**PLANNING BOARD RESOLUTION
VILLAGE OF MOUNT KISCO**

**NEGATIVE DECLARATON OF SIGNIFICANCE
PRELIMINARY AND FINAL SUBDIVISION APPROVAL**

**1 Leonard Street and 2 ½ Leonard Street
Burgler/Smoller Subdivision
Cal # PB2021-0409
January 24, 2023**

1 PROPOSED TRUCK ENTRANCE TURNING DIAGRAM
1" = 10'-0"

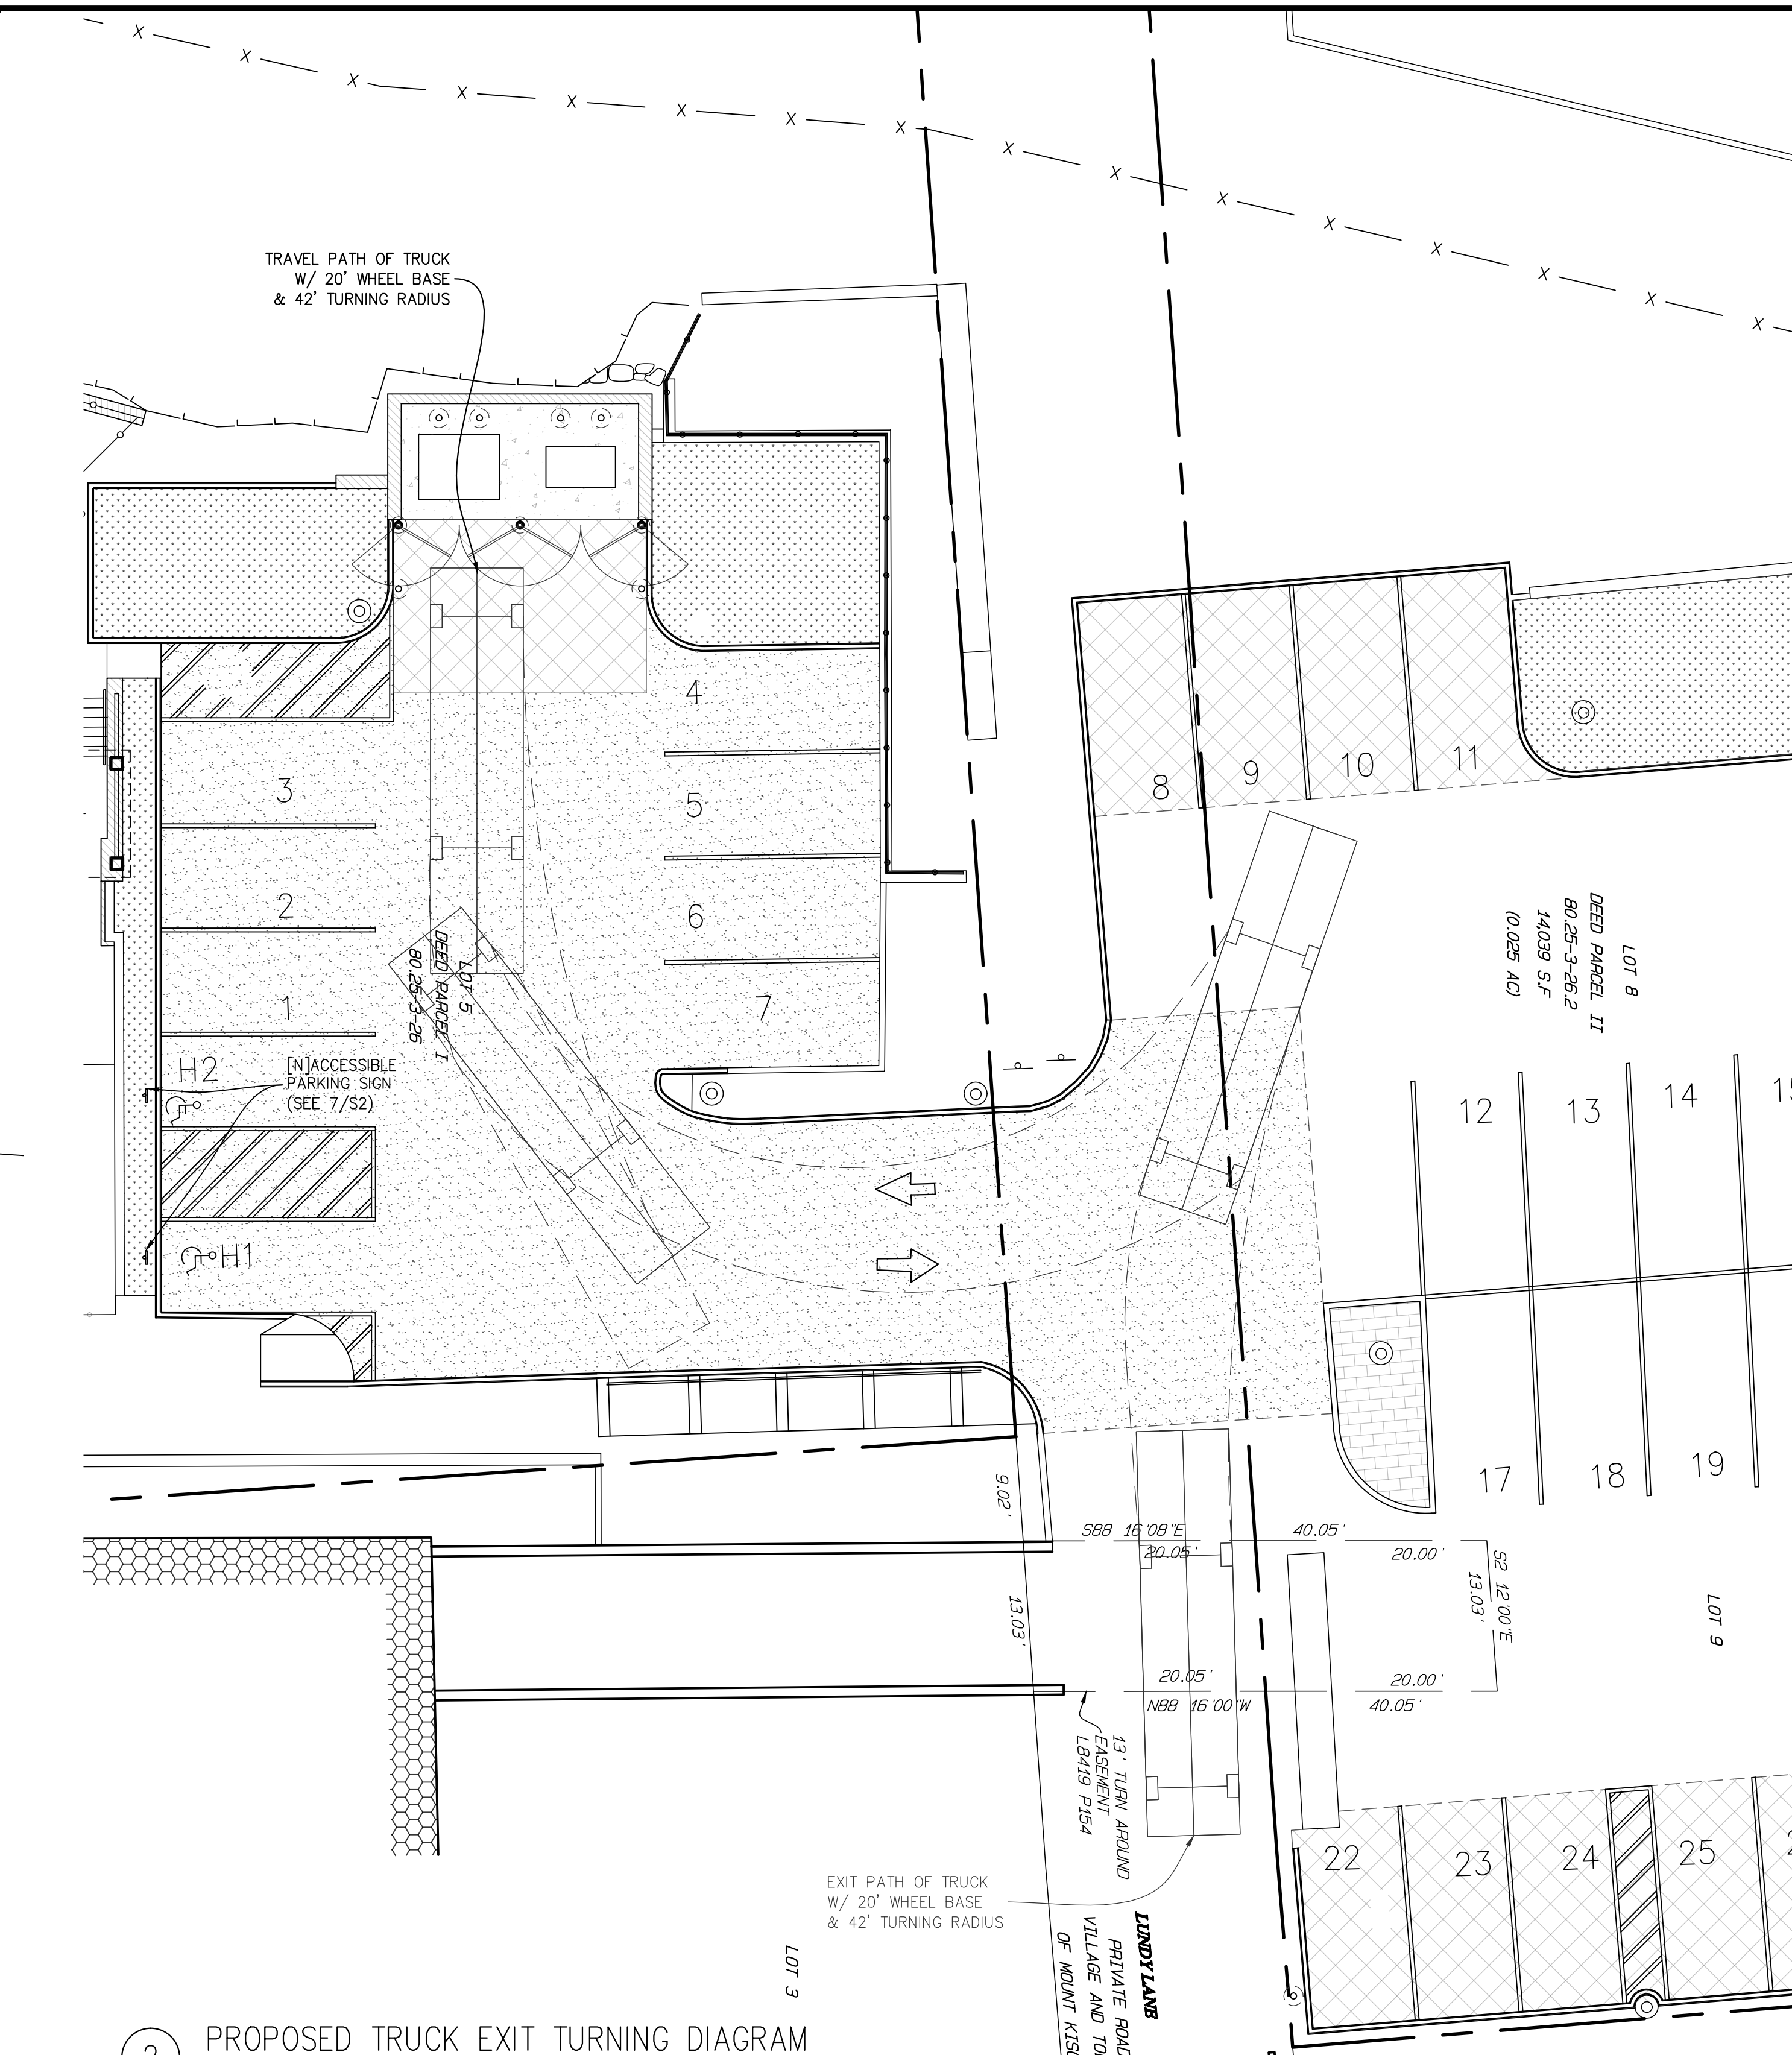
10. A truck turning plan within the upper parking area has been provided to demonstrate garbage truck/delivery truck access. A 46’ turning radius has been shown based on average Front-End Loader dimensions. Please see sheet S5 for truck turning plan with access to dumpsters shown.

1 PROPOSED WEST ELEVATION - MAIN STREET
1/8" = 1'-0"

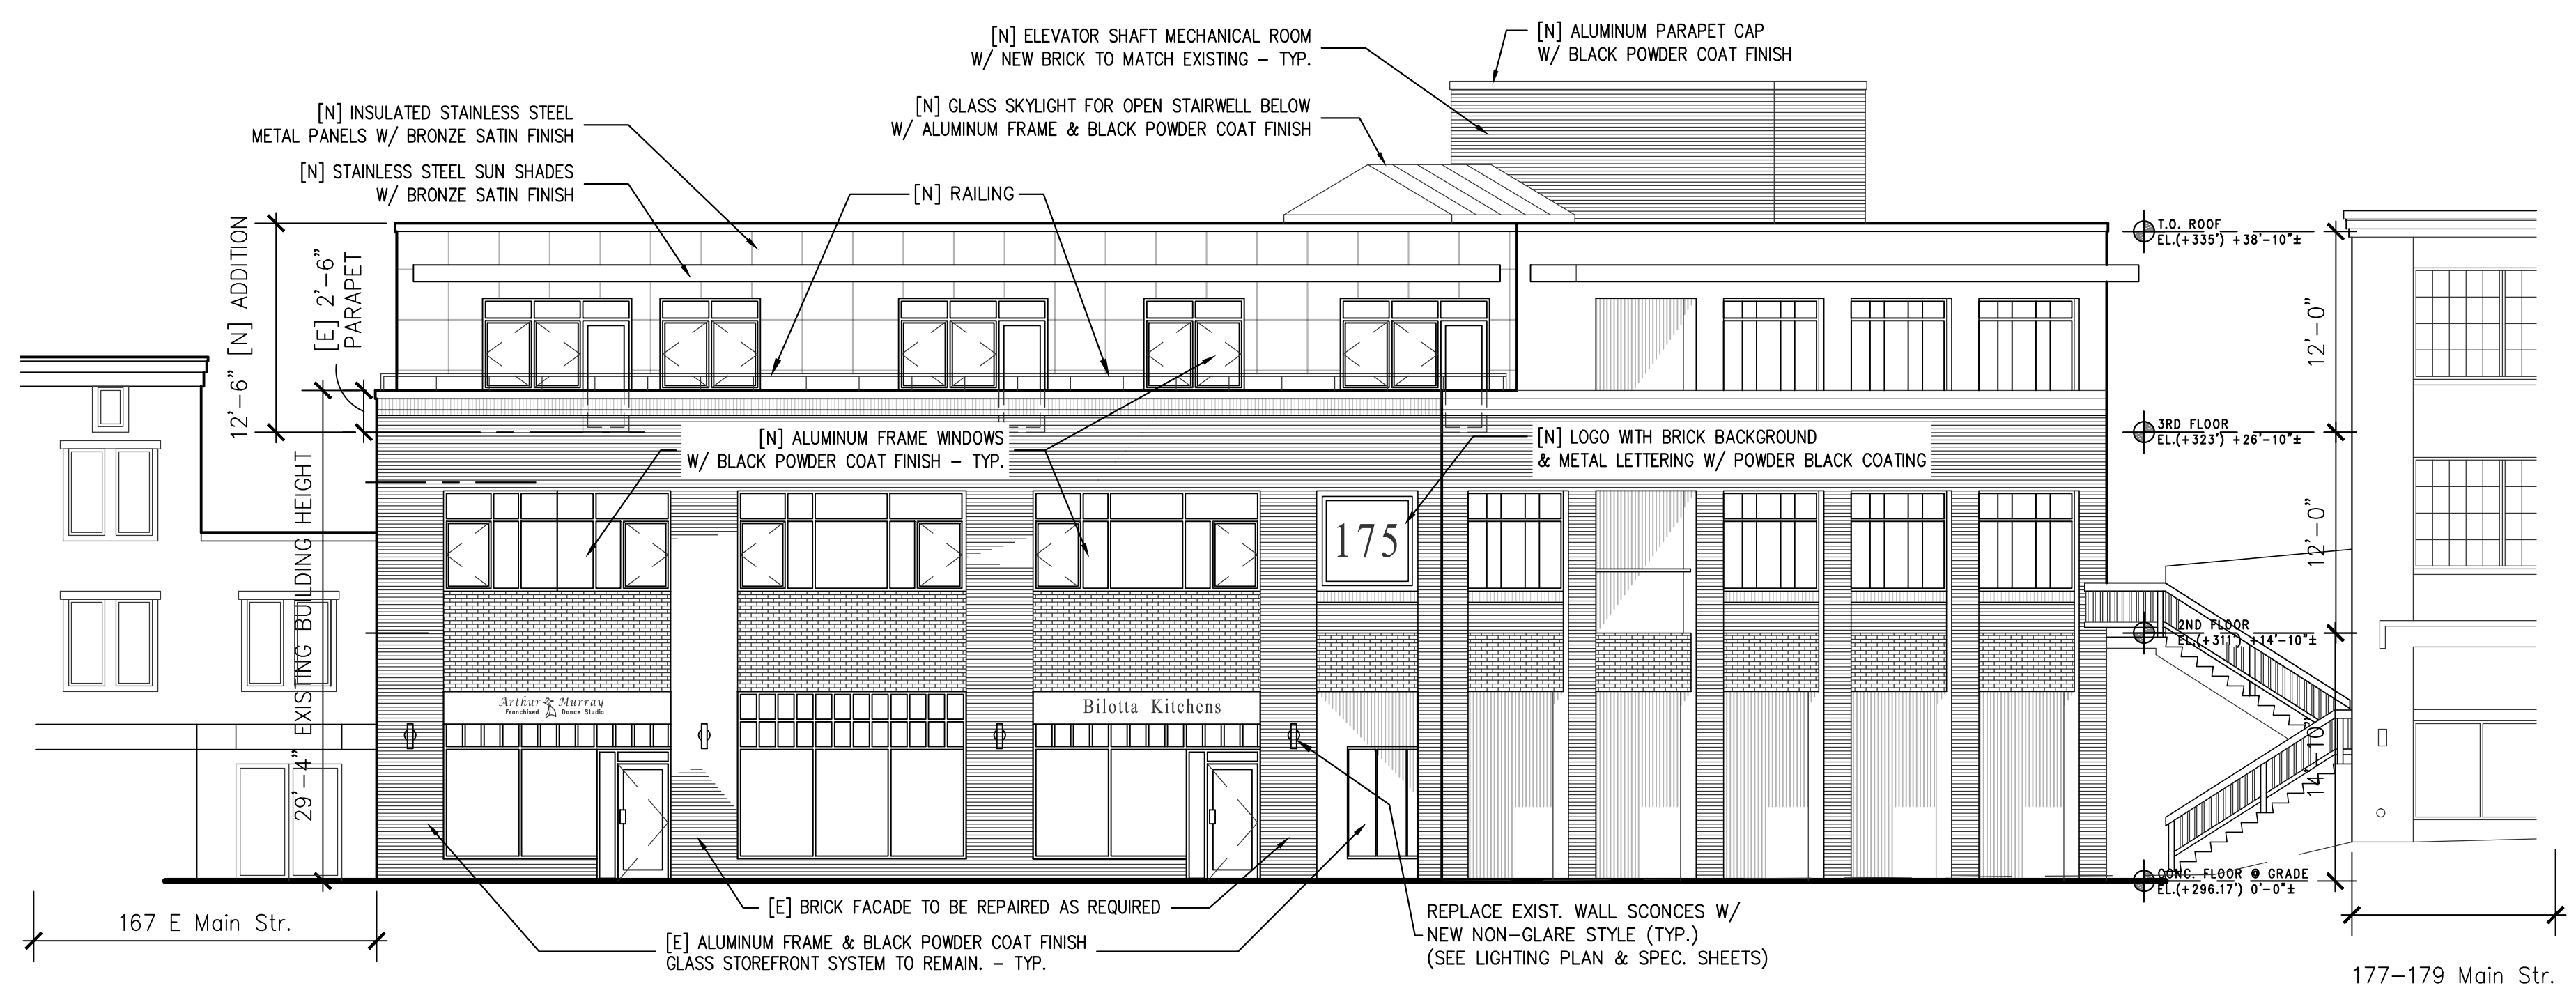
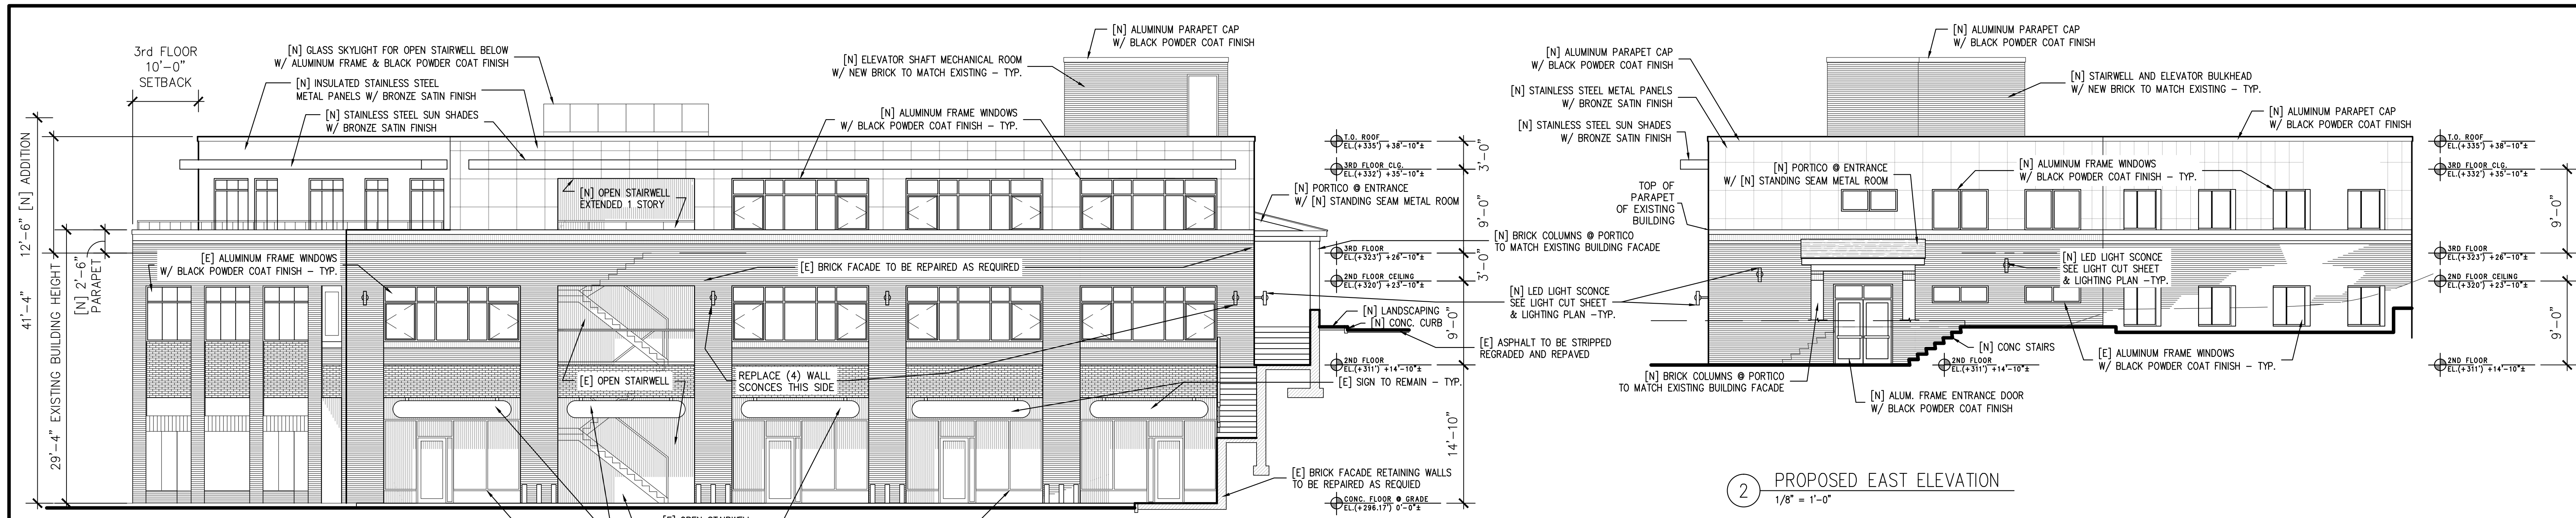
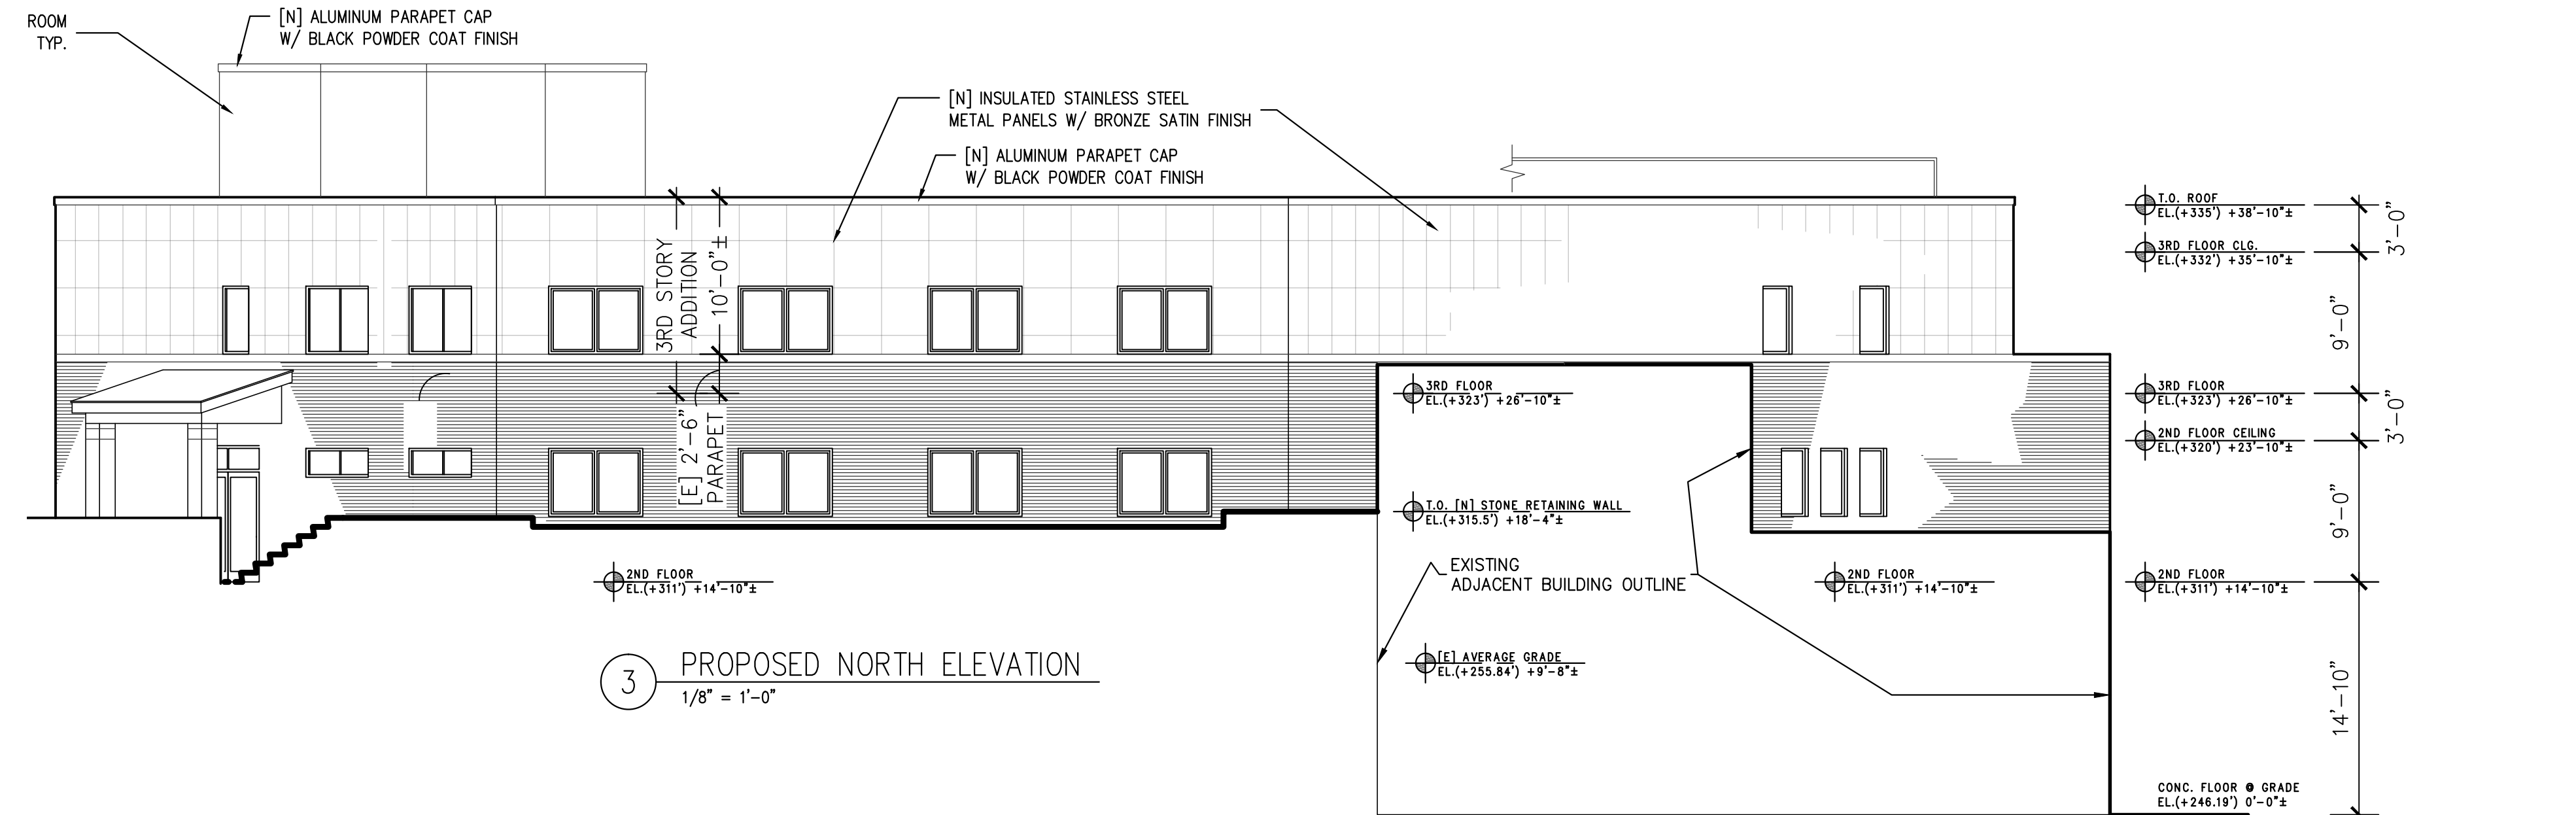
5. Construction materials and color specifications have been added to the Elevations, please see sheet A6 for Elevations.
6. Documentation associated with the “Fire Escape Easement” has been provided. And all work will be coordinated with adjacent owner.
